miniBrute DRSSTC Addendum

The following document outlines the known errors and omissions in the miniBrute DRSSTC design. These include both the book, *DRSSTC: Building the Modern Day Tesla Coil miniBrute Reference Design* as well as the PC Board design for the miniBrute DRSSTC.

miniBrute DRSSTC PCB Boards – REV-

6. Self-Resonant Control Board – ARTWORK mistake

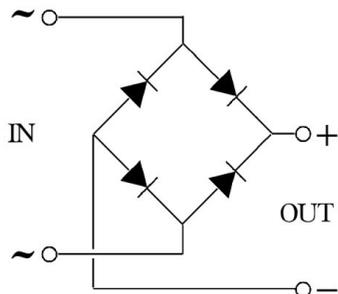
The top of potentiometer, R23 (page 20), should be connected to +15V. The REV- artwork has this node connected to +5V. To correct this, use the following instructions”

- a. First, cut the trace on the top of the board between the top pin of potentiometer, R23, and R25.
- b. On the bottom of the board, connect a jumper wire between the top pin of potentiometer, R23, and U23, Pin 8.

Without this modification, the current limit will be limited to about 475A peak current.
